UNITED STATES PATENT AND TRADEMARK OFFICE

APPLICATION NO.	FILING DATE	FIRST NAMED INVENTOR	ATTORNEY DOCKET NO.	CONFIRMATION NO.
10/764,160	01/23/2004	Robert C. Lyne JR.	P1035.lyne	8161

Office Action Summary	Application No. 10/764,160	Applicant(s) LYNE, ROBERT C.	
	Examiner Marc Jimenez	Art Unit 3726

DETAILED ACTION

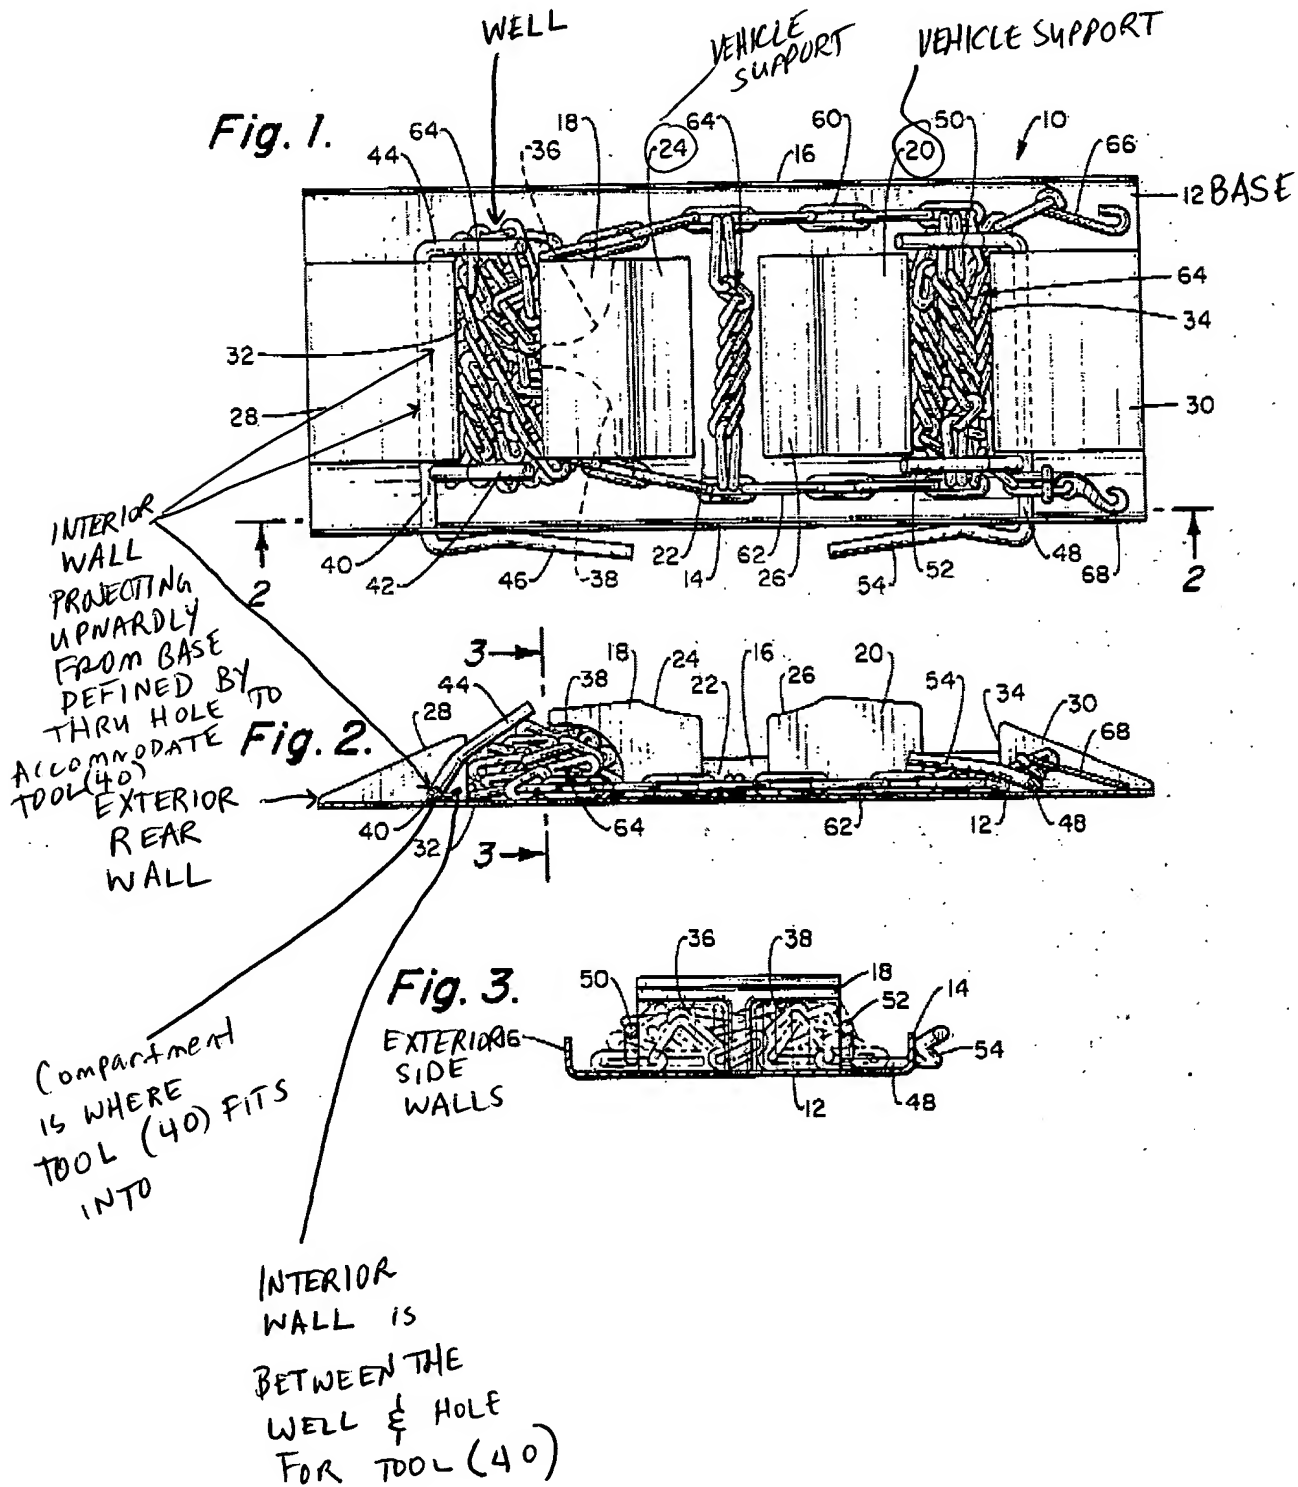
Planz teaches a base **12** having a longitudinal axis and, at opposite ends of the axis, a rear end **28** and a front end **30**, an exterior rear wall **28** and exterior side walls **14,16** projecting upwardly from the base **12**, a plurality of vehicle supports **24,26** projecting upwardly from the base **12** and being spaced from each other and from the side walls **14,16** so as to define longitudinal channels and transverse channels for receiving and confining laid-out side chains **62** and cross chains **64**, respectively, a well **64** for receiving side chains and cross chains which have not been laid out **38**, an interior wall projecting upwardly from the base defining, an upwardly facing compartment adjacent the well **64** for receiving the U-shaped tool and protecting from damage due to the weight of the vehicle, which compartment has a bottom defined by the base and a side defined by the interior wall, the interior wall being located between the well **64** and the compartment (the compartment is where the tool **44** is located, the compartment clearly has an “interior wall”), so as to keep the chain which has not been laid out contained in the well and

thereby prevent it from coming into the compartment during storage or handling of the tray. It is noted that the compartment 64 could also be considered a "well" and the tool 54 could be considered a "U-shaped tool". See also a copy of figures 1-3 of Planz below with each of the features labeled corresponding to the claimed invention.

Regarding claims 2-3, the wall defining the compartment where tool **44 or 54** is located is sufficiently high and is defined by a plurality of walls.

Regarding claim 4, the well **64** is defined by the rear wall and portions of the side walls **16,14**.

Regarding claim 7, the side walls **14,16** have a relatively greater height defining the well **64** and a relatively lesser height near the supports **24,26**. The side walls are relatively greater in height compared to the well and a relatively lesser height compared to the supports.

Regarding claim 8, the interior wall **32** separates the well **64** from a substantial portion of the compartment.

Regarding claim 9, since there are two tools **44,54**, one could be considered a “U-shaped tool” and the other could be considered “a chain element holder”.

7. Applicant's arguments with respect to claims 1-9 have been considered but are moot in view of the new ground(s) of rejection.
8. Applicant argues that Planz does not teach interior walls and a compartment. However, in figure 1 of Planz, the ramp **28** is a solid piece as evidence with the dashed lines which is an outline of the tool **40**. Therefore, there is a through hole across the width of the ramp **28** to accommodate the tool **40**. As shown in figure 2 and figure 3, the tool is contacting the top surface of base **12**. The through hole accommodating the tool and the wall labeled **32** could therefore be considered "interior walls". Furthermore, because there is a through hole to receive

the tool **40** as shown by the dashed lines in figure 1, the through hole could be considered a “compartment” because the through hole accommodates the tool **40**.

9. Applicant argues that Planz does not disclose any structural feature that can be reasonably be called a “compartment”. However, the ordinary dictionary definition of “compartment” is “One of the parts or spaces into which an area is subdivided”. The space in which the tool **40** fits into is clearly a space that is subdivided from another area in the tray.

11. Applicant argues that Planz does not disclose a wall or any other feature “located between the well and the compartment”. However, the through hole along the width of the ramp **28** to accommodate the tool **40** is considered a compartment. Between the “compartment” and the well where the chains are located at **64** in figure 1 has a “wall” which separates the compartment from the well.

12. The element labeled **40** is considered a “tool” as claimed because a tool could be any type of device that performs a function. Although as shown in figure 2, the tool may be above member **18**, the tool could easily be placed below the member **18** as shown at **54**.

14. In response to applicant's request for clarification of each of the structural elements of Planz that constitute the claimed well, interior wall and compartment, see the marked up copy of figures 1-3 above.
